**MONTGOMERY COUNTY
PLANNING COMMISSION**

Re: MCPC # 24-0175-001
Plan Name: Southeast Psychiatric Treatment Center at Norristown
(1 lots comprising 65.77 acres)
Situate: Sterigere Street (NE), between Colonial Drive (NW) and Forest Avenue (SE)
West Norriton Township

PRELIMINARY/FINAL LAND DEVELOPMENT PLAN
FOR
SOUTHEAST PSYCHIATRIC TREATMENT CENTER PHASE 1 - NORRISTOWN STATE HOSPITAL
1001 STERIGERE STREET
NORRISTOWN, WEST NORRITON TOWNSHIP, PENNSYLVANIA

ROADWAY DESIGN

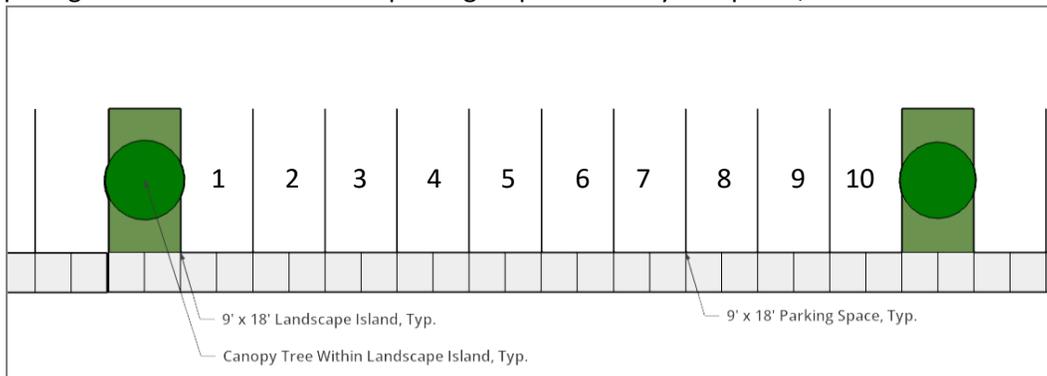
- 1) It is recommended that the municipality and applicant discuss an alternative roadway design at the eastbound and westbound approaches to the relocated main entrance, which is proposed to align with the intersection of West Sterigere Street and Montgomery Avenue. At present, eastbound vehicles turning left into the facility have a tendency to cause congestion. It is therefore recommended that the municipality and applicant discuss the need for an eastbound left turn lane at the main entrance.

- 2) It is recommended that the municipality and applicant discuss minor roadway improvements to address westbound left turns at the intersection of Forrest Avenue and West Sterigere Street. The striping that delineates a westbound left-turn lane (to Forrest Avenue) and the westbound through lane have degraded to the point that repainting is required.

- 3) It is recommended that internal roadways be designed to accommodate large vehicles, such as SEPTA buses. With the anticipated number of employees and the potential increase for visitors to the facility, future transit service should be considered.

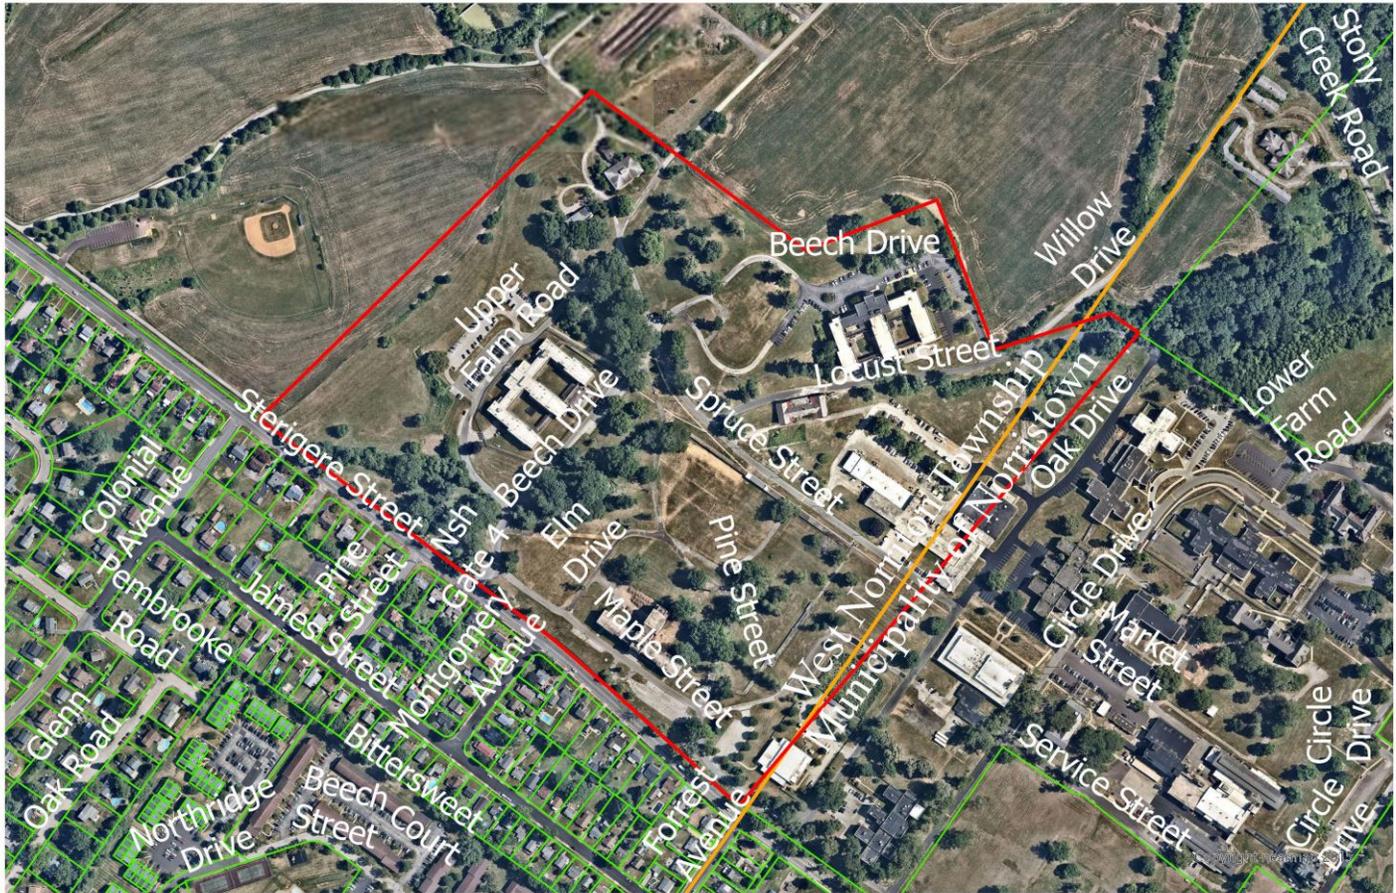
- 1) Landscape islands with canopy trees are recommended to be provided no less than every 10 parking spaces. Landscape islands should take up the area of a parking space. Given that the applicant is proposing to exceed the minimum parking requirement by 31 spaces, there should be adequate space

available to provide landscaping islands internal to the rows of parking. Please see the graphic below for a demonstration of landscape island size and location.
